RE: 7707 Central Ave NW

Conceptual Grading & Drainage Plan Engineer's Stamp Date: 06/03/21 Hydrology File: K10D063

Based upon the information provided in your submittal received 06/04/2021, the Conceptual Grading & Drainage Plan is preliminary approved. The following comments need to be addressed for approval for Grading Permit, Paving Permit, and Floodplain Development Permit of the above referenced project:

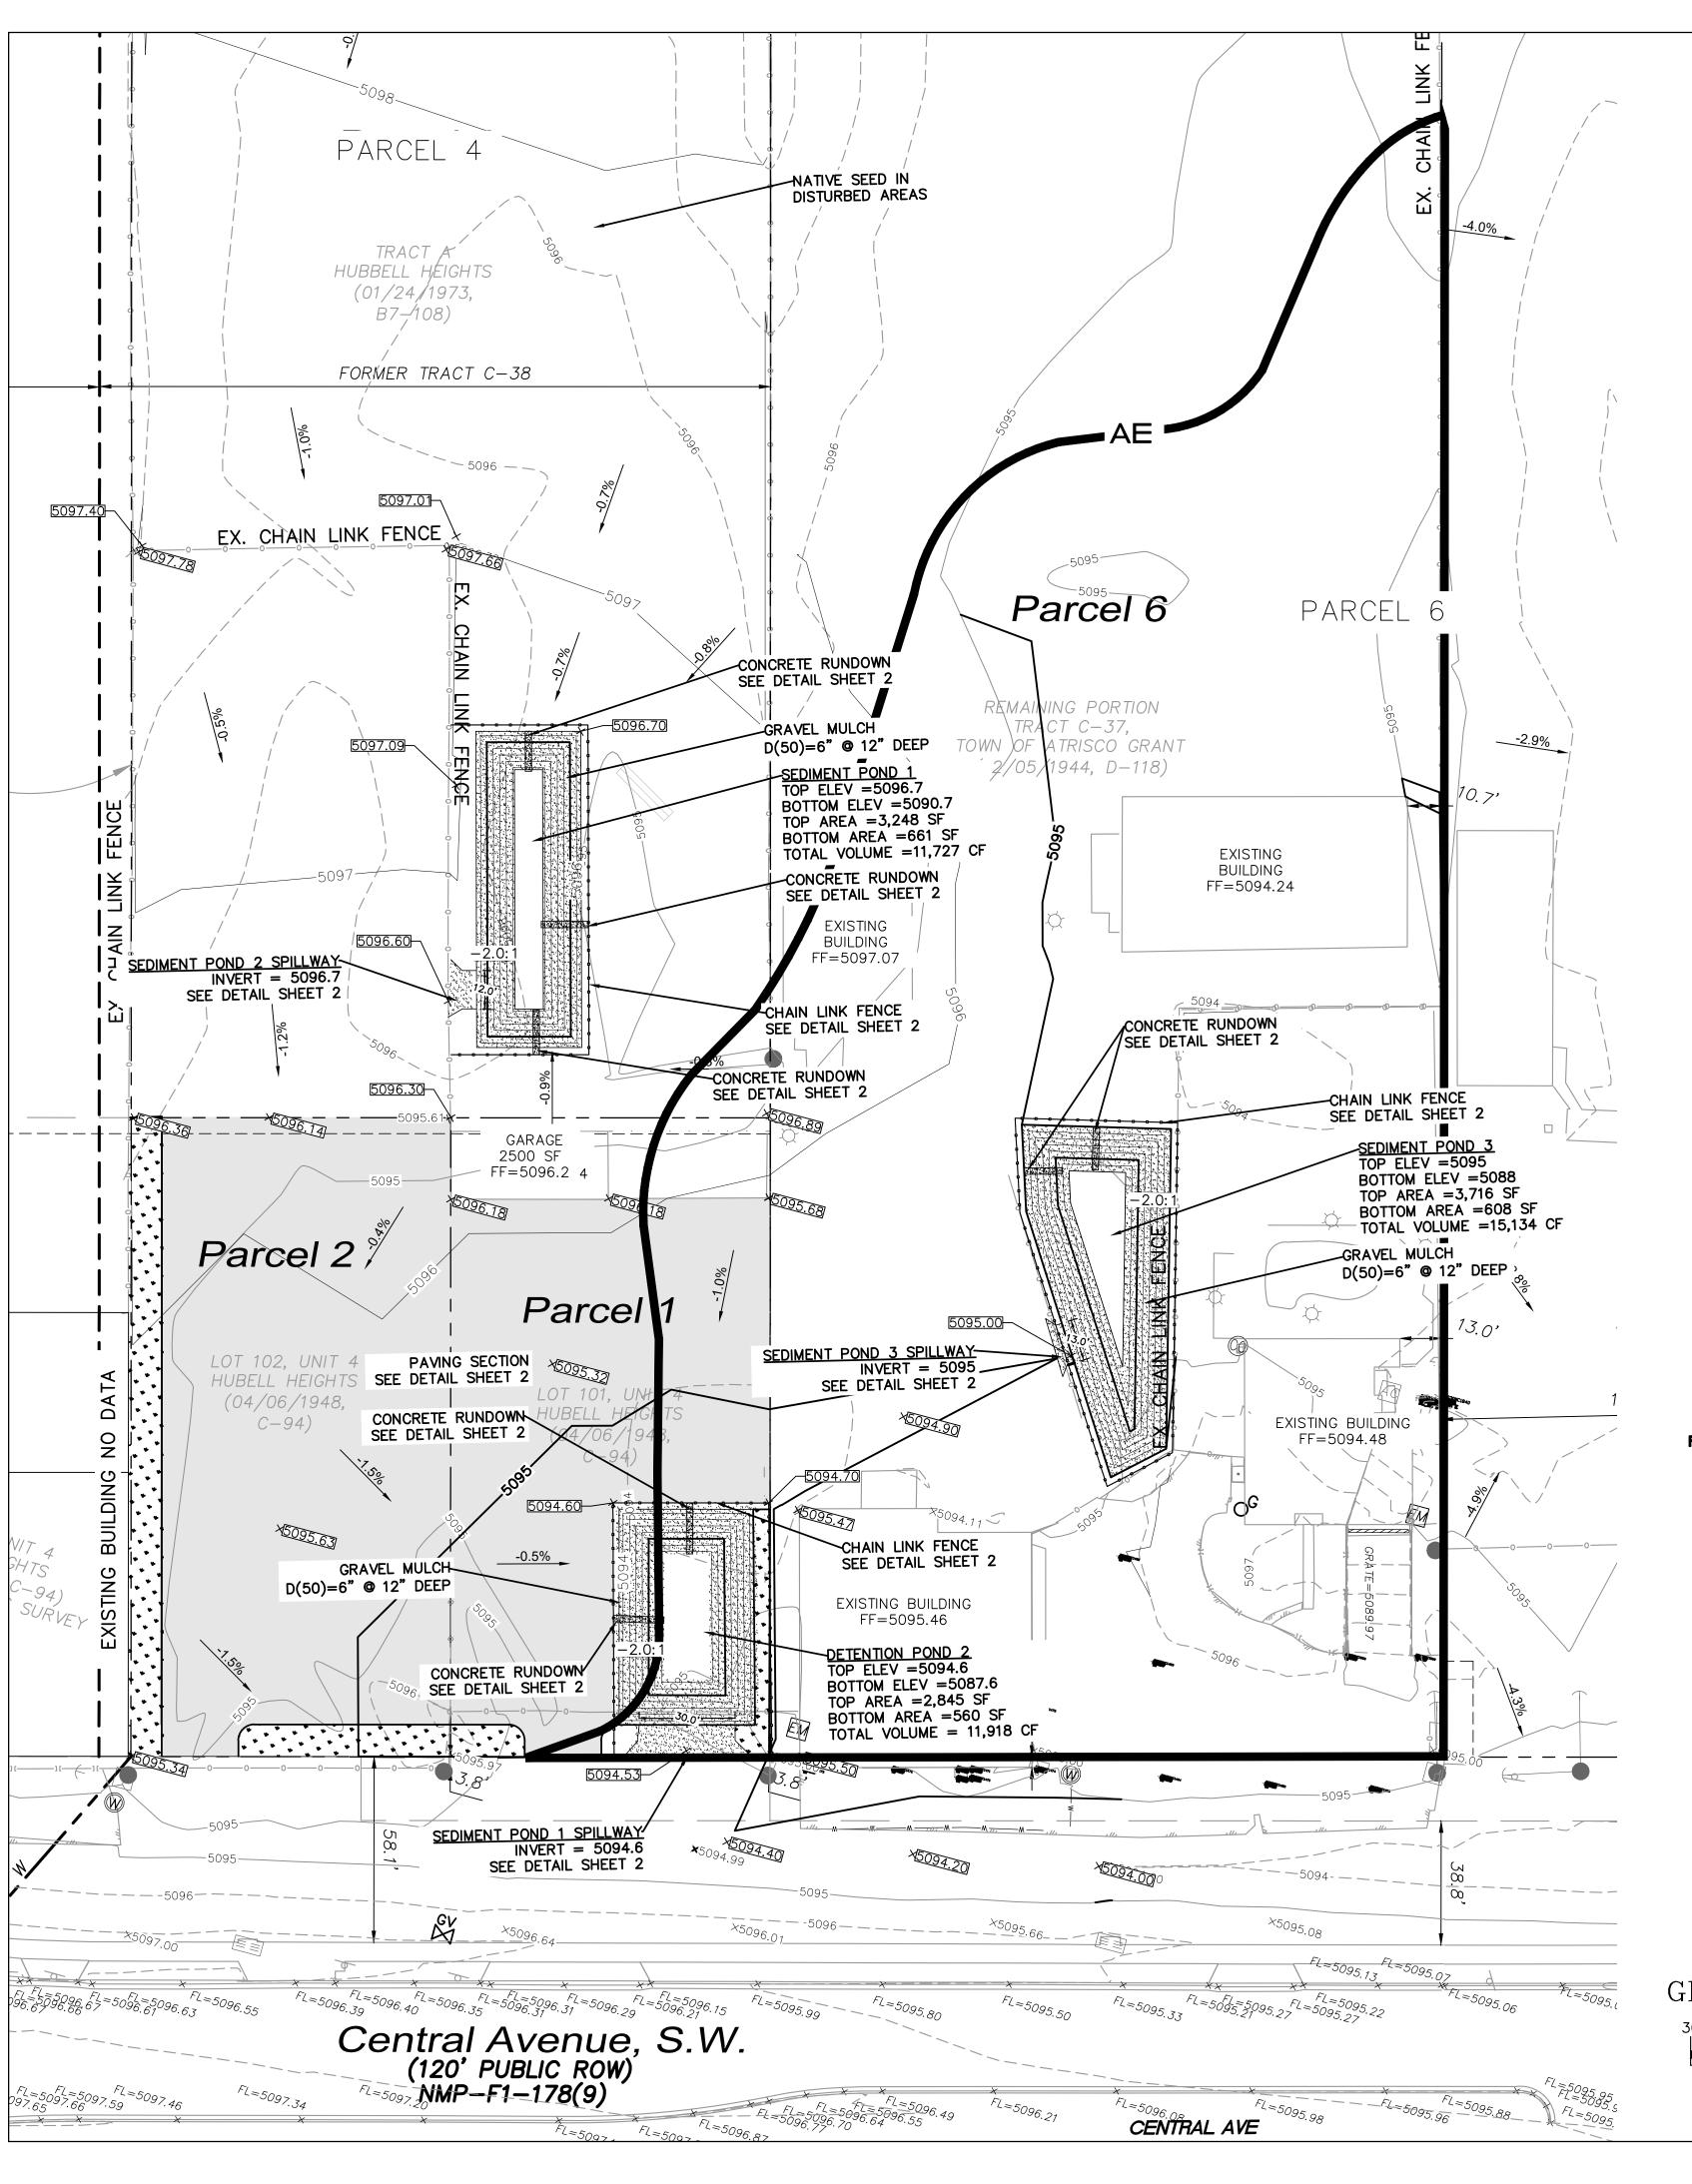
2. Please provide a net sum gain of zero or negative with respect to the cut and fill within the floodplain area only. Please check FEMA's regulations with respect to this activity within the floodplain.
